Timing in PHY startup (D2.1 Comment #169)

Rev a (first presented in 9/4/19 ad hoc)

IEEE P802.3ch Multigig Automotive Ethernet PHY Task Force
George Zimmerman ((General) Ad Hoc Chair),
CME Consulting, Inc

Comment 169

Figure 149-33—PHY Control state diagram

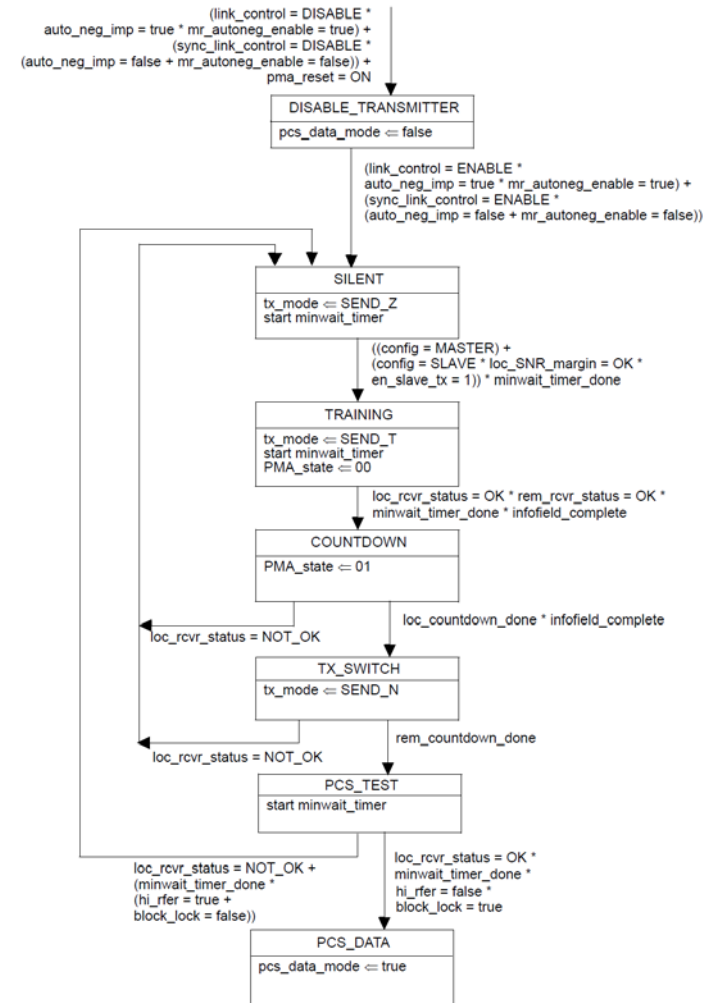
To ensure interoperability during the training phase, certain timing allocations between Master, Slave and other steps of training must be observed. We propose to the text of 802.3bz for interoperability and just scale the timing of 10G mode and deduct the timing for PCS_TEST that is set by min_wait_timer.

tModify Figure 149_33 as attached and Include the associated Table 145.15 in section 149.4.2.4.10 page 147, line 35 to read as follows

MASTER	SLAVE	MAX REQUIRED TIME
-----	-----	-----
Traning	Silent	40.00 msec
Training	Training	57.02 msec
PCS Test	PCS Test	0.98 msec
TOTAL		98.00 msec

- PHY control must complete in no more than 97 msec or risk being terminated by the link_fail_inhibit_timer
 - 97 msec, Max = 98 msec (see 98.5.2)
- No timers control times in:
 - SILENT
 - TRAINING
 - COUNTDOWN/TX_SWITCH
- Experience from 10GBASE-T showed different designers made different assumptions of the time distribution
 - Discovered after initial publication, so it was a recommendation, not a requirement

Insert new final paragraph to 149.4.2.4.10 Startup sequence (Page 147 line 35): "The startup timing shall comply with Table 145-15 for MASTER, and Table 145-16 for SLAVE."

Insert new tables 145-15 and 145-16 at end of 149.4.2.4.10:

Timing Interval	Maximum time (msec)
From entry to SILENT state until en_slave_tx = 1 is transmitted	40
From transmission of en_slave_tx = 1 until entry to COUNTDOWN state	$55.975 - 0.384/S$
Entry to COUNTDOWN until exit of TX_SWITCH	$0.384 / S$
Entry to exit of PCS TEST	1.025
Total (Entry to SILENT to exit of PCS TEST)	97 msec

Timing	Maximum time (msec)
Entry to exit of SILENT state	40
Entry to exit of TRAINING state	$55.975 - 0.384/S$
Entry to COUNTDOWN until exit of TX_SWITCH	$0.384 / S$
Entry to exit of PCS TEST	1.025
Total (Entry to SILENT to exit of PCS TEST)	97 msec
